BID ADDENDUM #2

Bid # RFB-2022-15

SUNY SCCC WELCOME CENTER

C2 DESIGN PROJECT #2006

1 PARTIAL FIRST FLOOR PLAN
 SCALE: 3/16" = 1'-0"

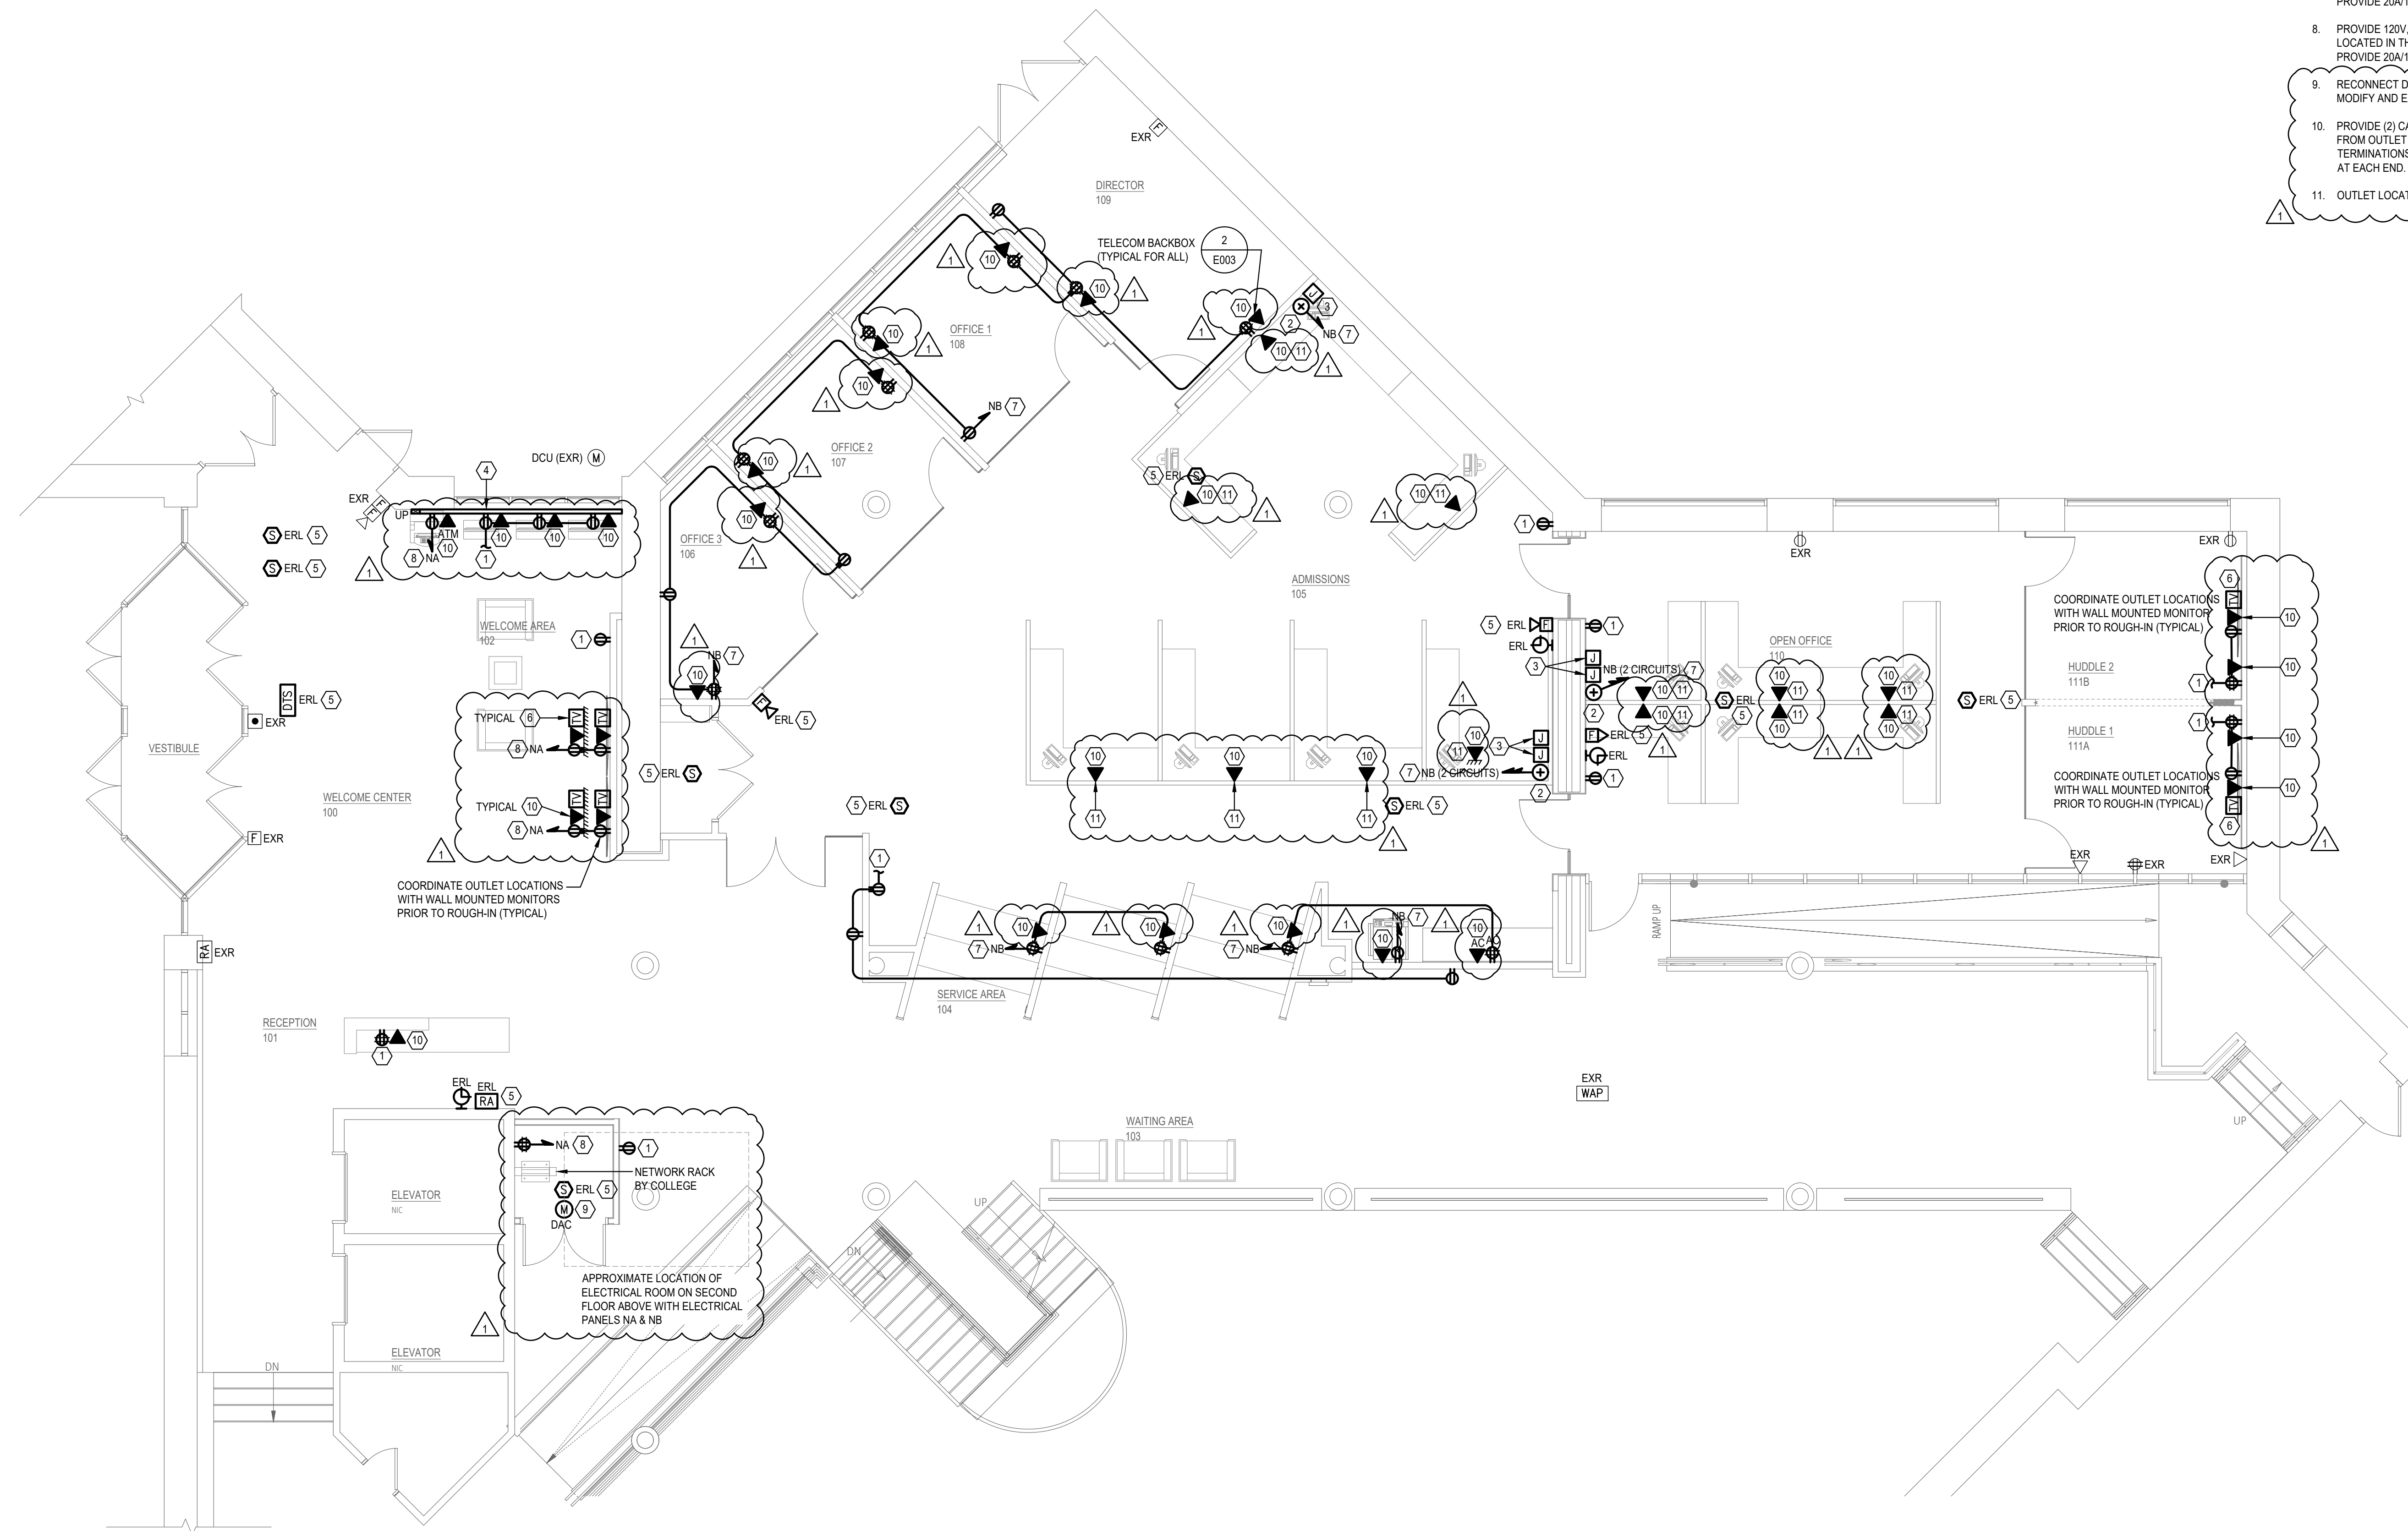
Drawing E301/ Partial First Floor Lighting Plan:

- Detail 1, Partial First Floor Plan:
 - Revision as noted.

1 PARTIAL FIRST FLOOR PLAN
 SCALE: 3/16" = 1'-0"

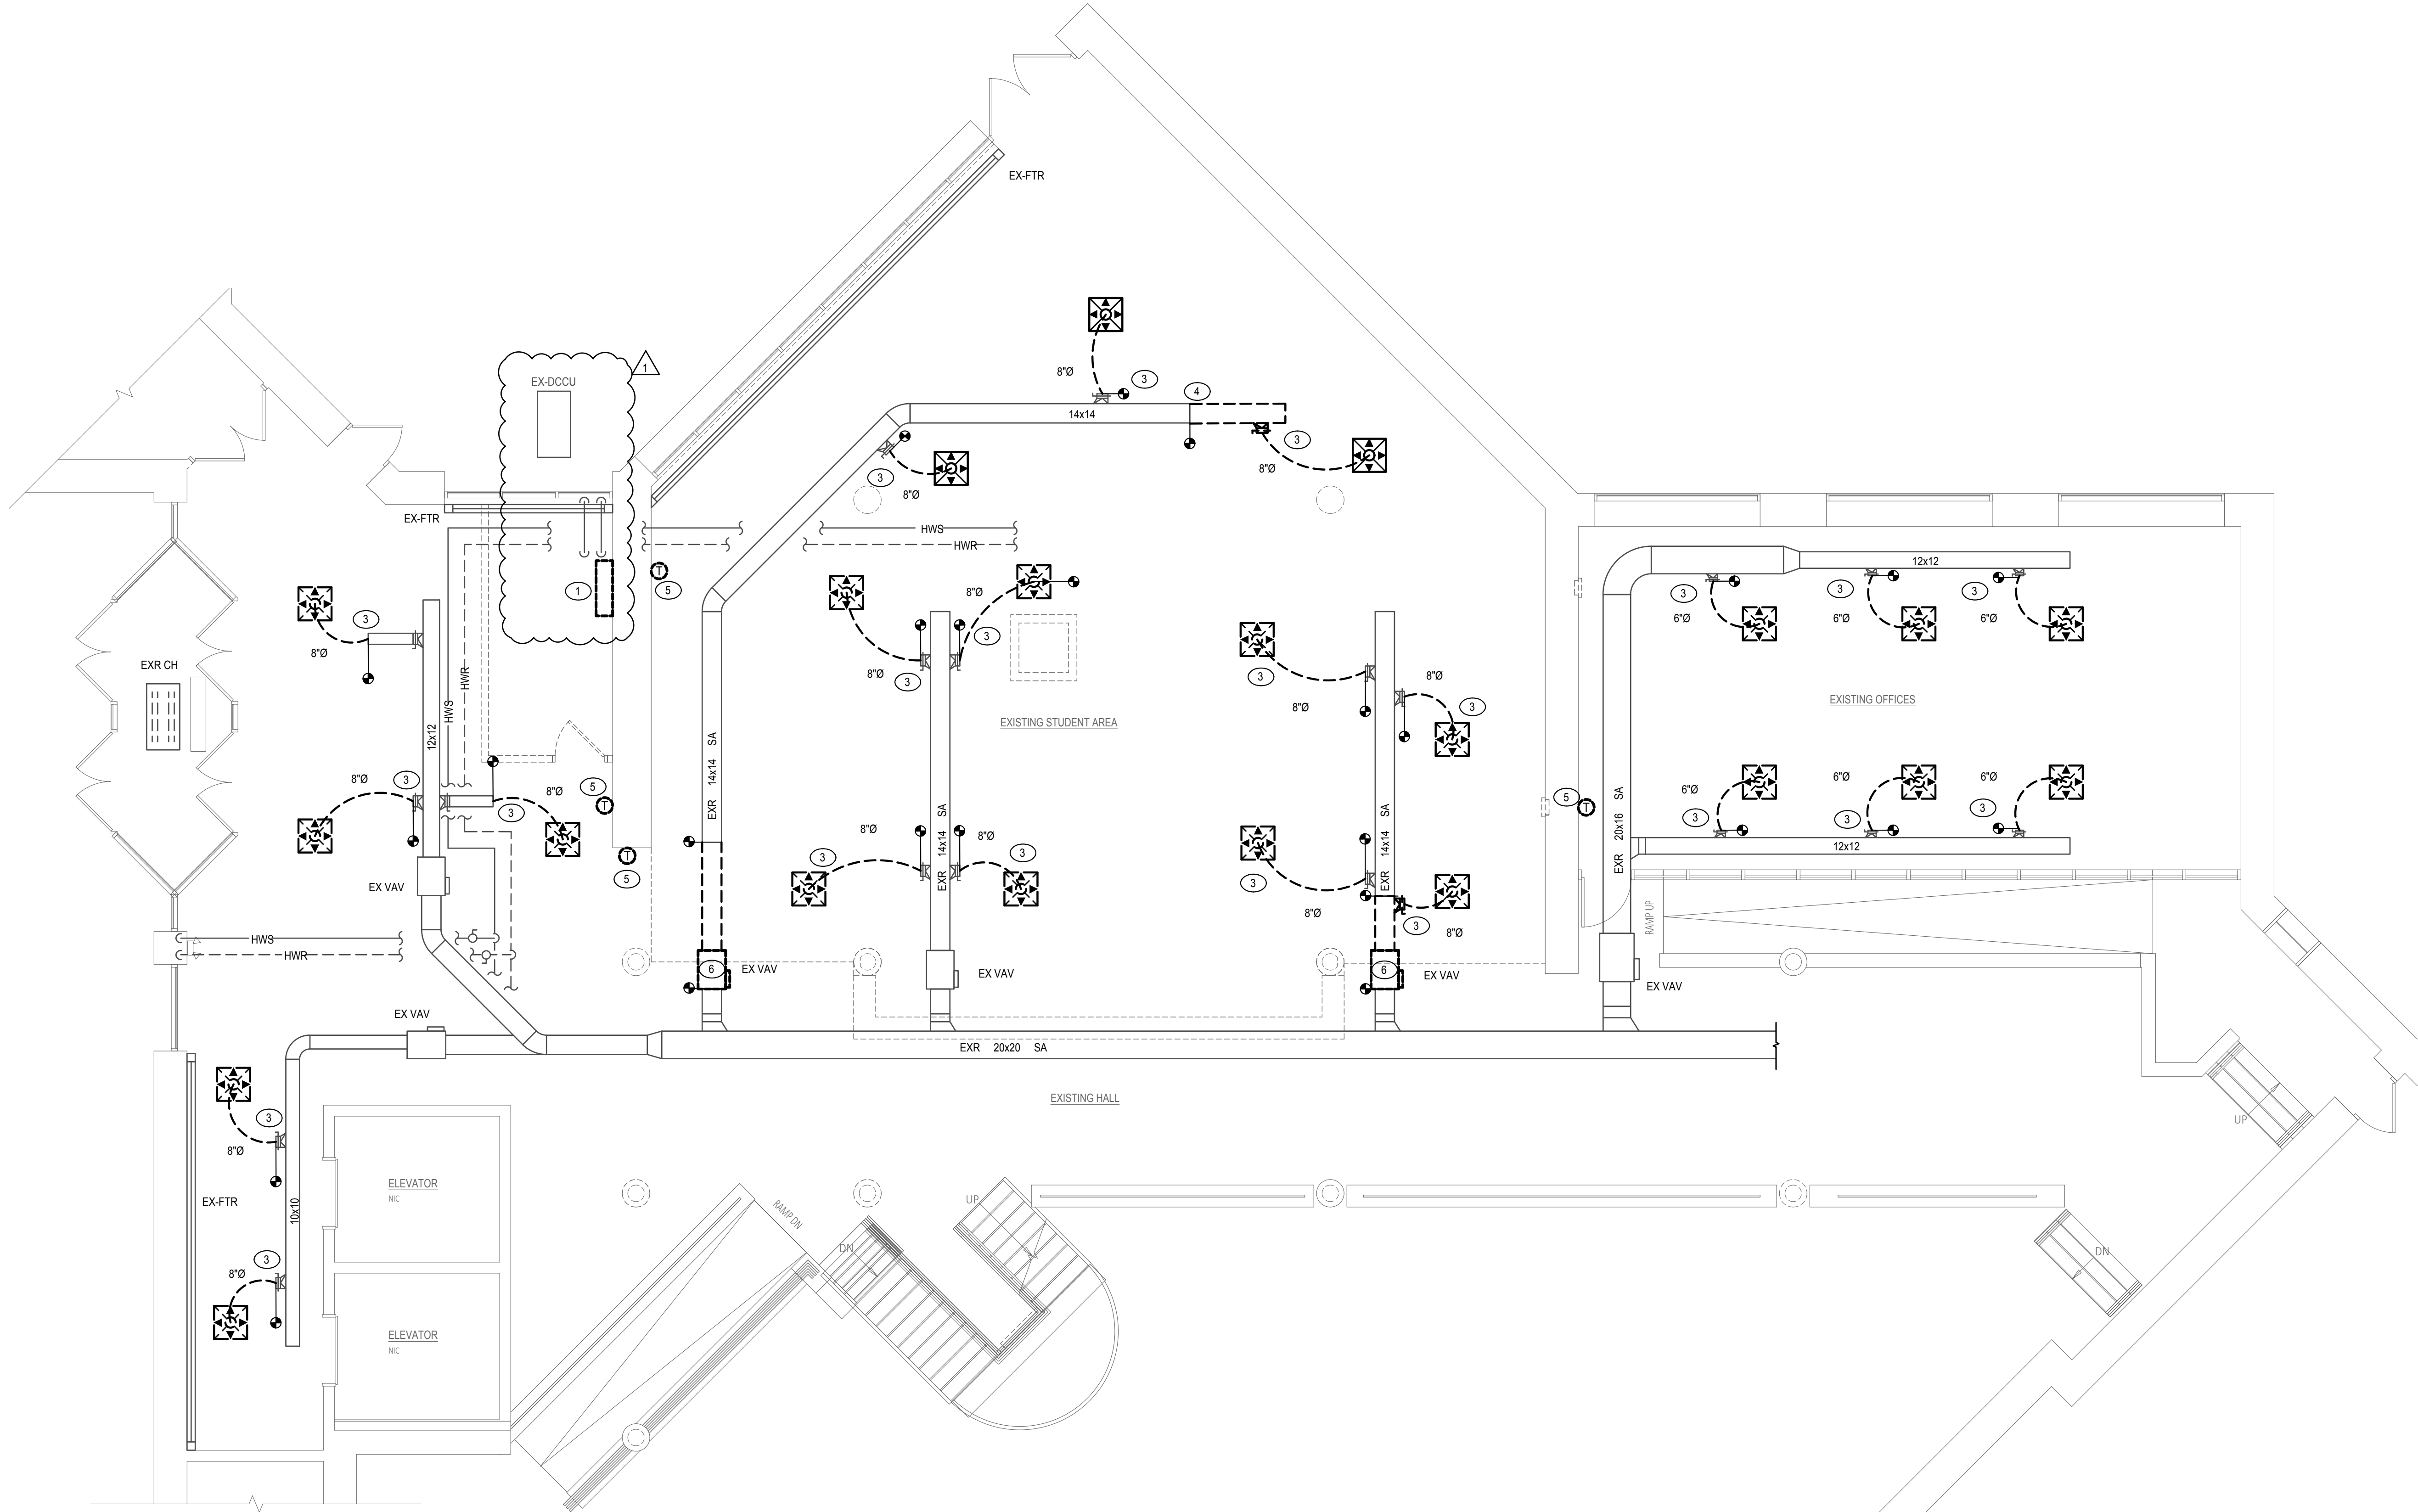
Drawing E401/ Partial First Floor Power & Systems Plan:

- Detail 1, Data room 112:
 - Provide (2) 4 data outlets in room (revise Note 10).
- Detail 1, Partial First Floor Plan:
 - Revisions as noted.
- Drawing Notes:
 - Revision as noted.

1 PARTIAL FIRST FLOOR PLAN
M201 SCALE: 3/16" = 1'-0"

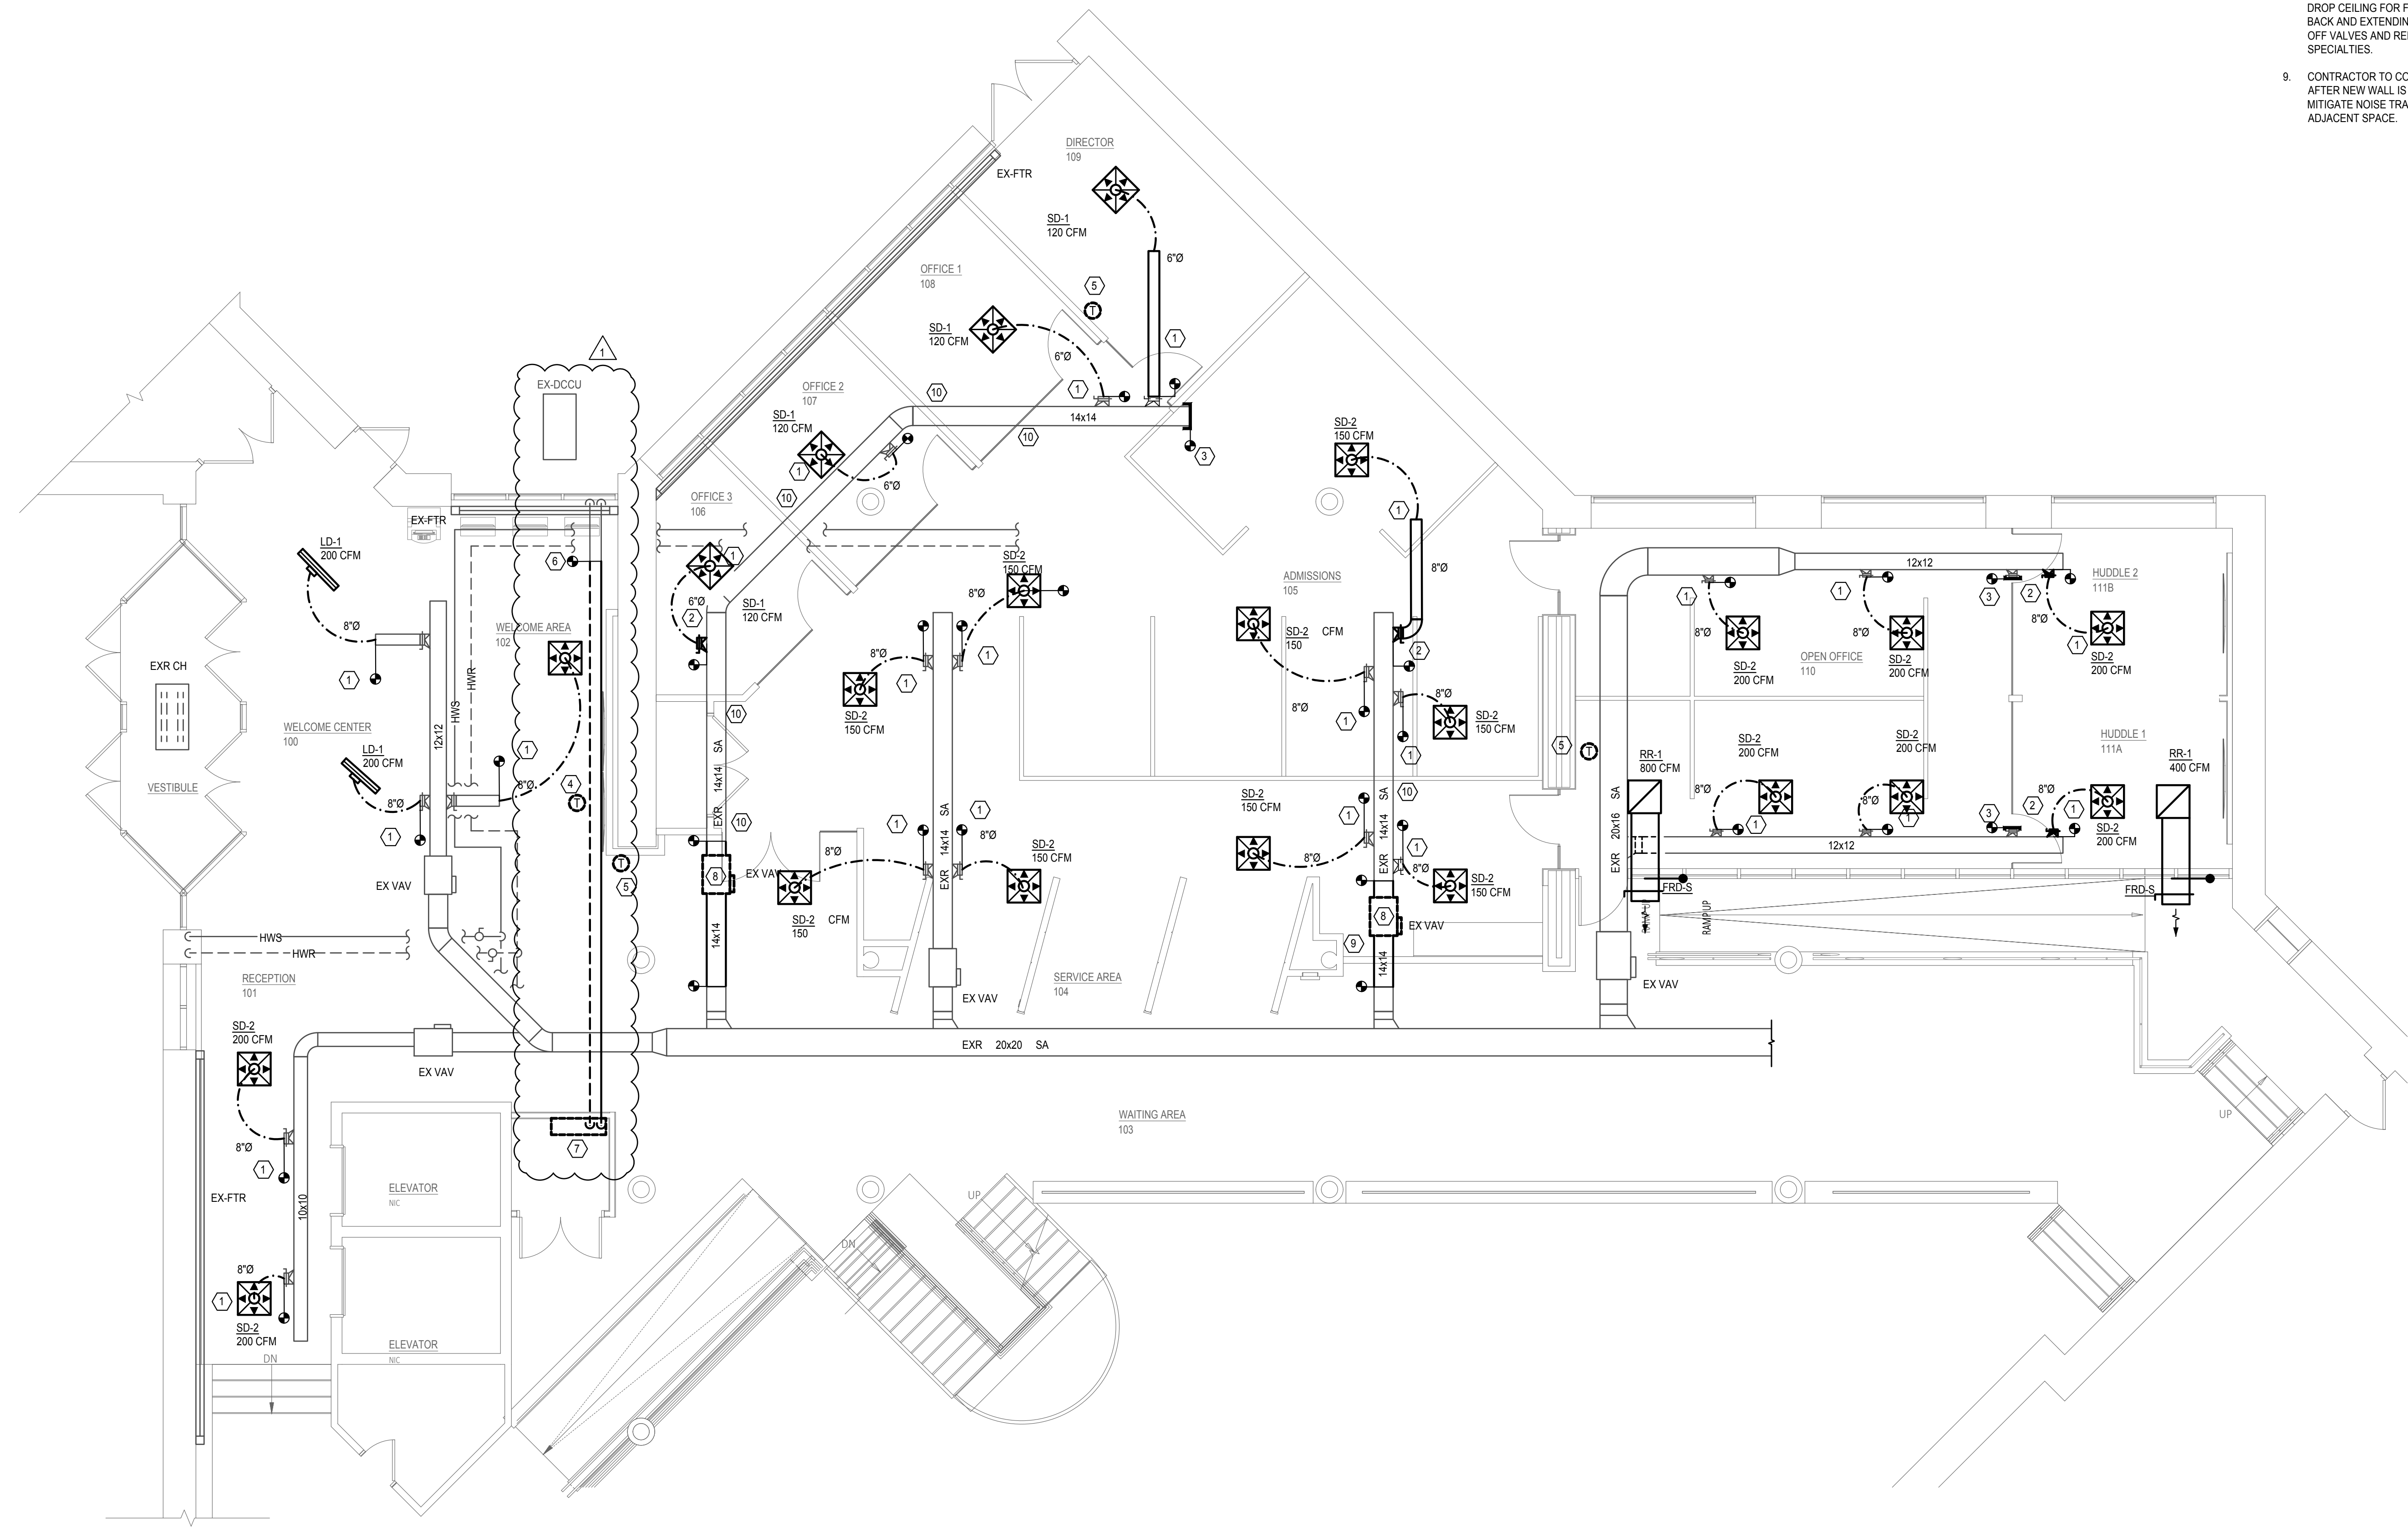
Drawing M201/ Partial First Floor Removal Plan:

- Detail 1, Partial First Floor Plan:
 - Revisions as noted.
- Removal Notes:
 - Revision as noted.
